Licence Number L7815/2001/11

Licence Holder Saracen Metals Pty Ltd

Premises North Eastern Goldfields Operations

Amendment

Figure 1: General arrangement drawing for Stage 6 embankment raise works for TSF Cell A (works highlighted in yellow) (Knight Piesold 2017a)

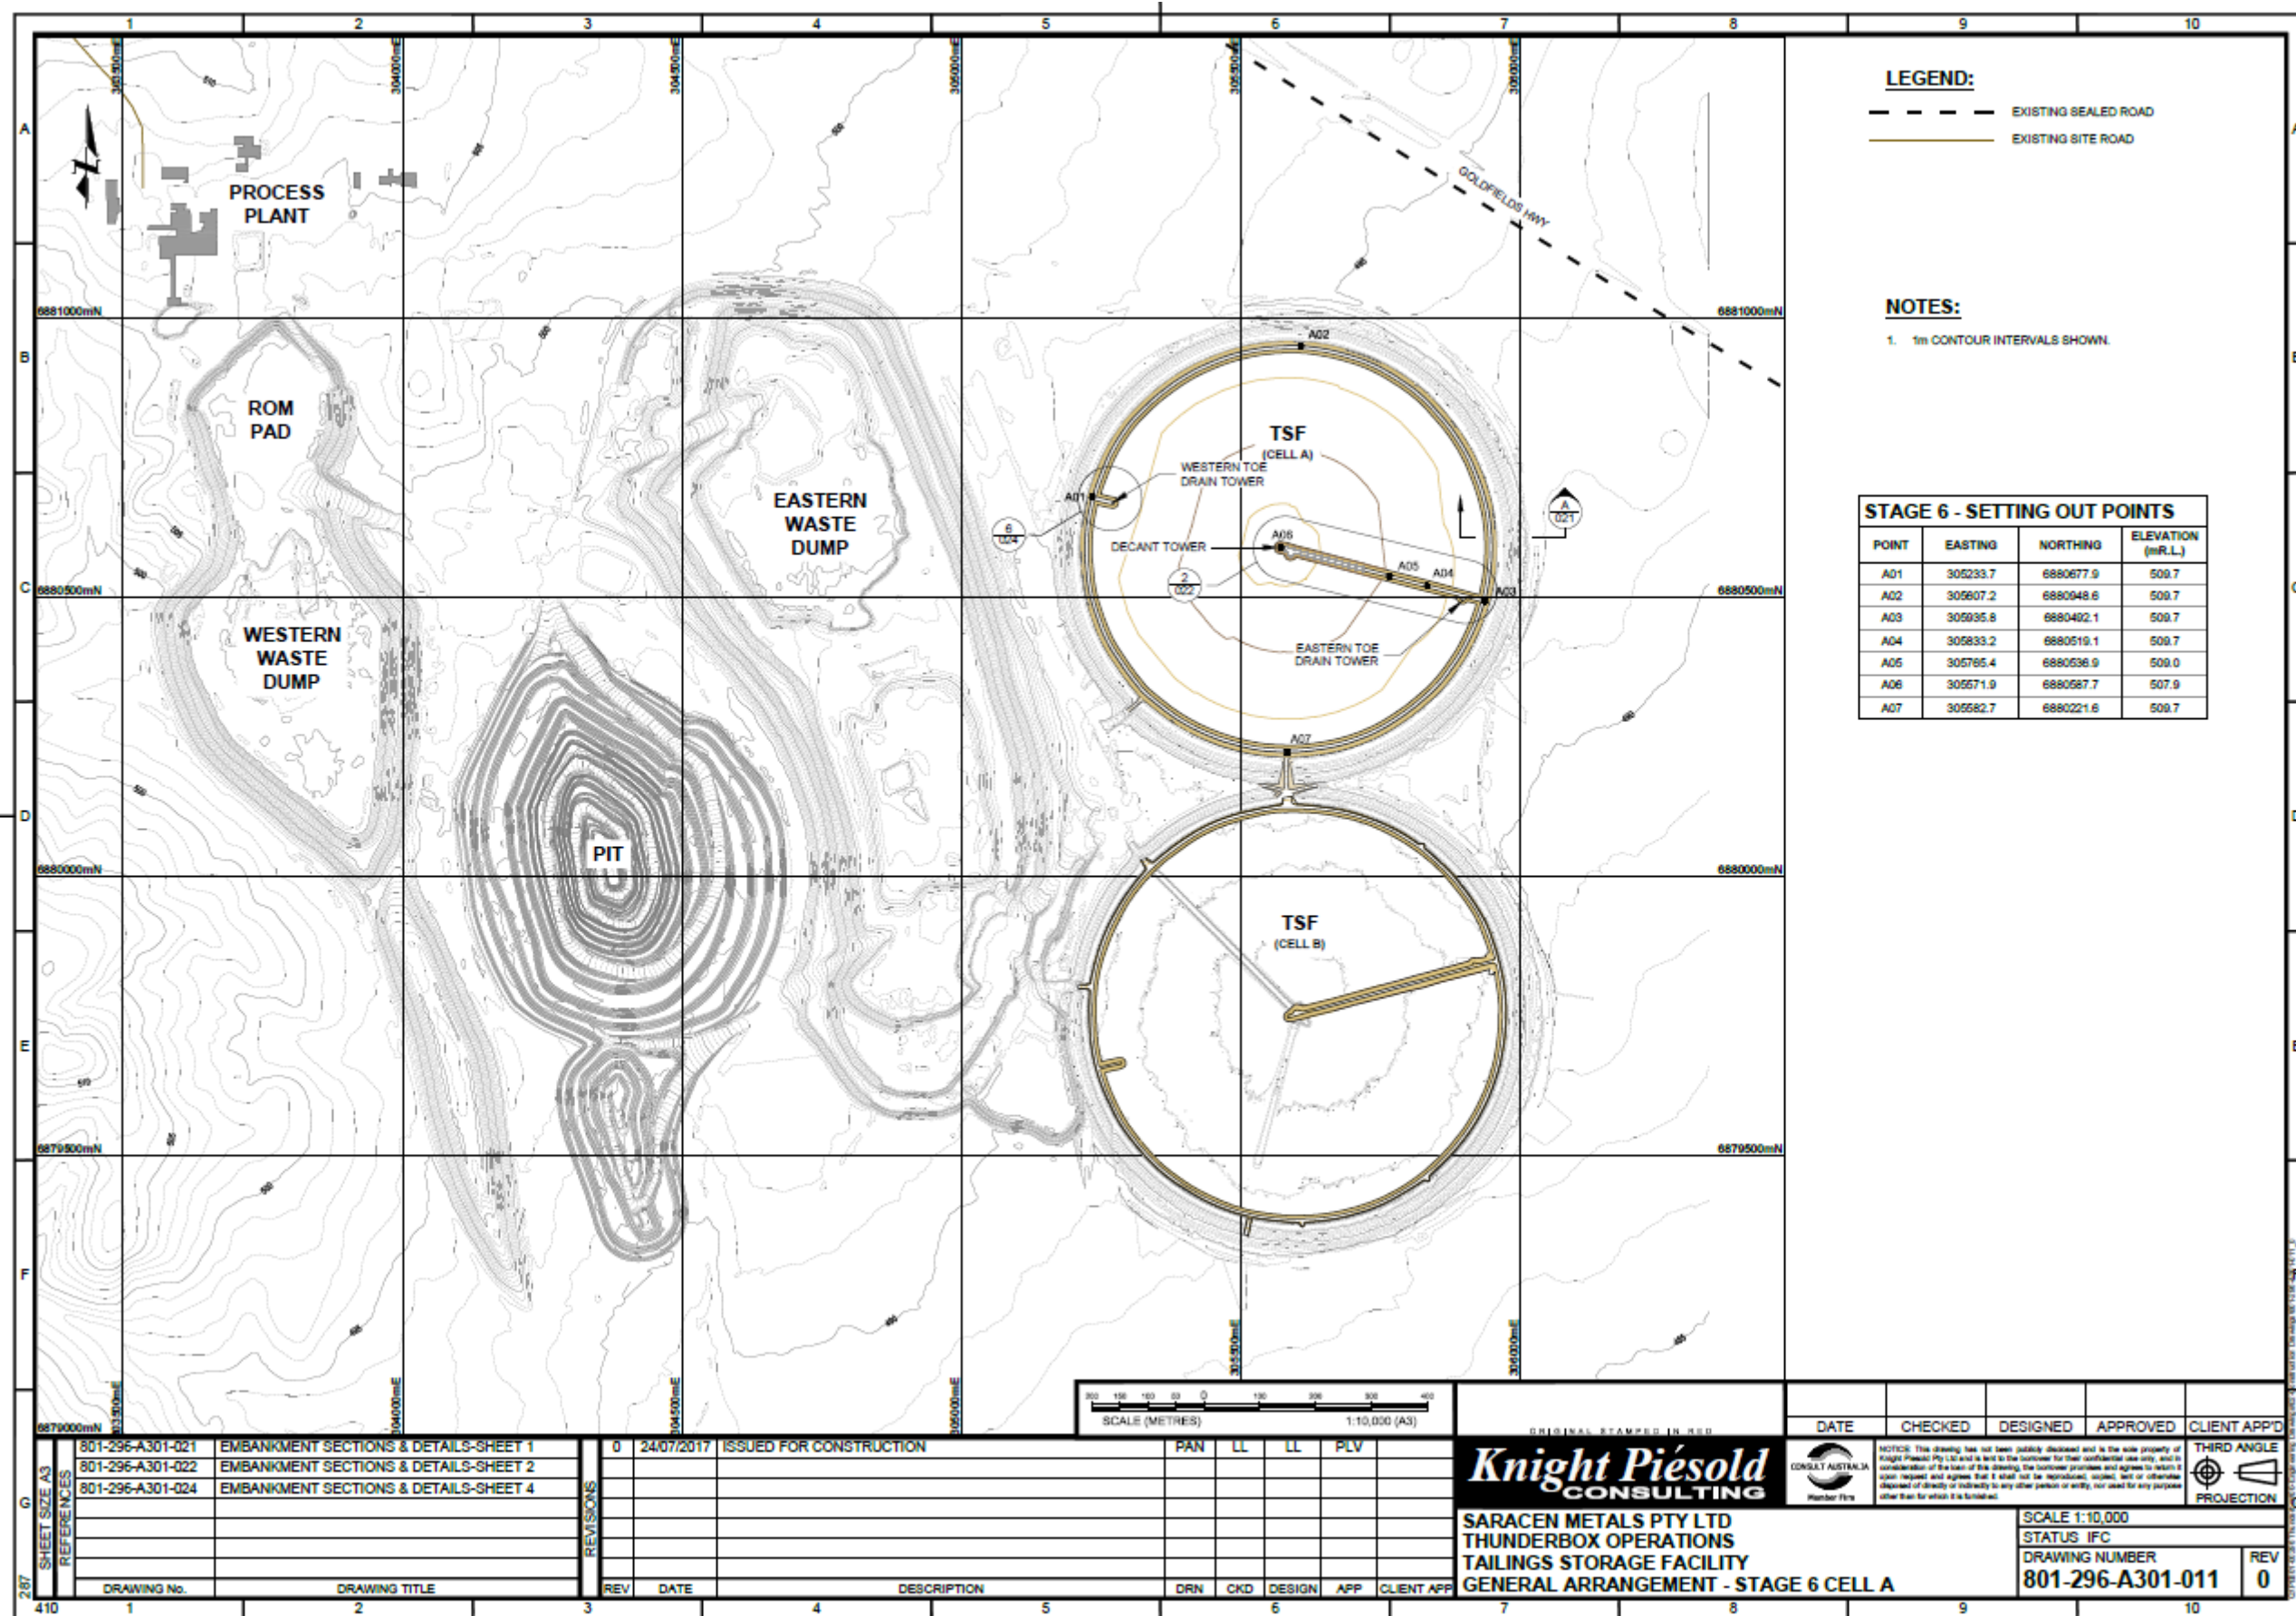
DWER received an application to amend Licence L7815/2001/11 to construct an embankment lift to Cell A of the tailings storage facility (TSF) from the current height of RL509.0 m to RLx m. this is also referred to as the stage 6 lift.

The Stage 5 embankment lift was authorised under Works Approval W5794/2015/1. The Stage 6 embankment raise adheres to the Tailings Storage Facility design that was the basis of the works approval (Saracen 2014). Knight Piesold have completed a technical specification for the scope of works for the embankment raise, consistent with the design report by Coffey (Knight Piesold 2017a; Knight Piesold 2017b). The scope of the works are as shown in Figures 1, 2 and 3 following.

Table 1.3.5: Infrastructure and equipment requirements		
<u>Column 1</u>	<u>Column 2</u>	<u>Column 3</u>
<u>Infrastructure/ Equipment</u>	<u>Requirements (design and construction)</u>	<u>Site plan reference</u>
<u>Stage 6 embankment raise to TSF Cell A</u>	<ul style="list-style-type: none"> <u>Construct an upstream embankment raise to the perimeter embankment of TSF Cell A from a starting embankment crest height of RL 507.0 m to completion at RL 509.7 m, in accord with Knight Piesold (2017a) General Arrangement drawing 801-296-A301-011 (Figure 1 of this Amendment Notice);</u> <u>Raise the eastern and western toe drain towers as per Knight Piesold (2017b) drawings 801-296-A301-023 and 024 (Figures 2 and 3 of this Amendment Notice);</u> <u>Complete decant return system raise works comprising an access causeway, decant tower with 1,800mm diameter slotted concrete pipe surrounded by clean waste rock, submersible pump and pipework and hoist and pulley to raise and lower the pump; and</u> <u>Install four piezometers within the completed Stage 6 embankments.</u> 	<u>TSF Cell A location shown in Figure 4 of Schedule 1.</u>

Figure 8: Thunderbox Landfill Locations

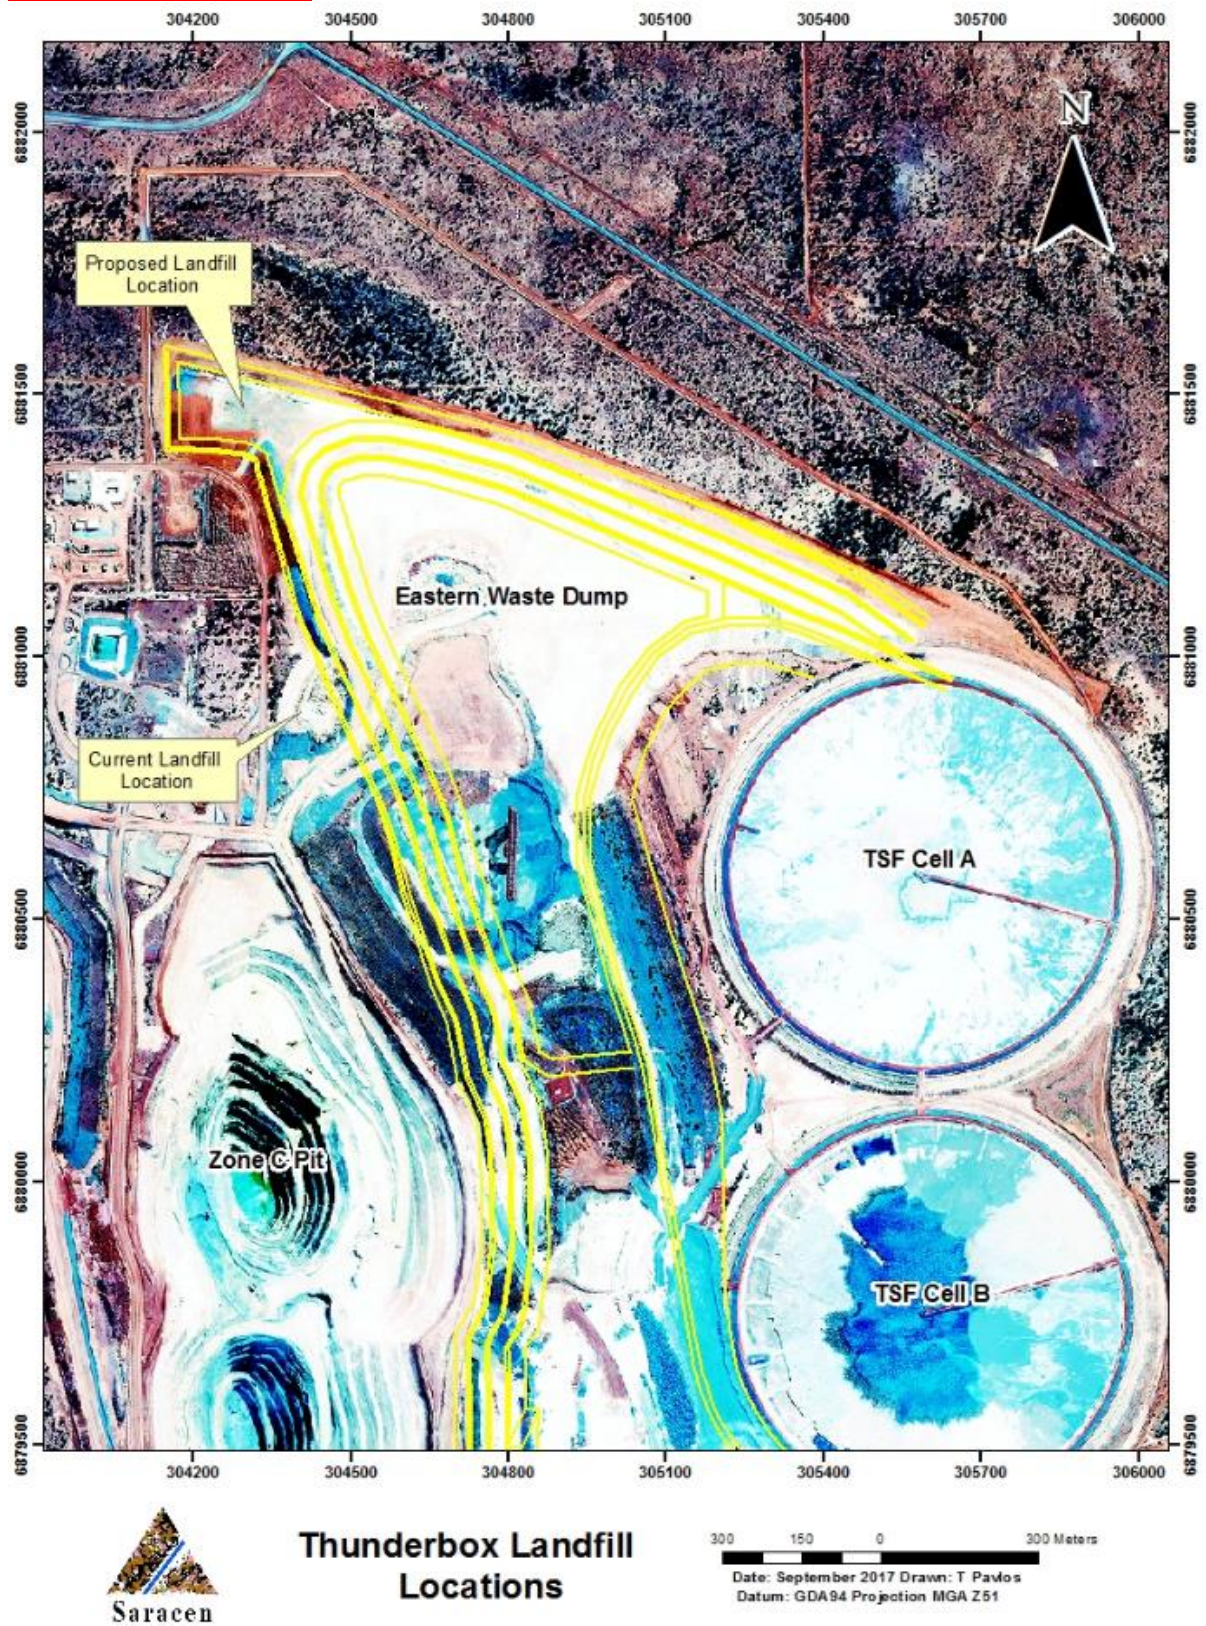
A new Figure (Figure 8) has been added to the Licence to show the additional landfill location. Existing Conditions 1.3.7 - 1.3.10 apply.

10. Schedule 1 of the Licence is amended by the addition of Figure 8 below:

Condition	Summary of Licence Holder comment	DWER response
3.3.1	Reminder that MB1 has been destroyed by Eastern Waste Rock Dump development so should be removed from Table 3.3.1.	Accepted
- Schedule 1	Map provided of new landfill location to include in the Licence.	Accepted
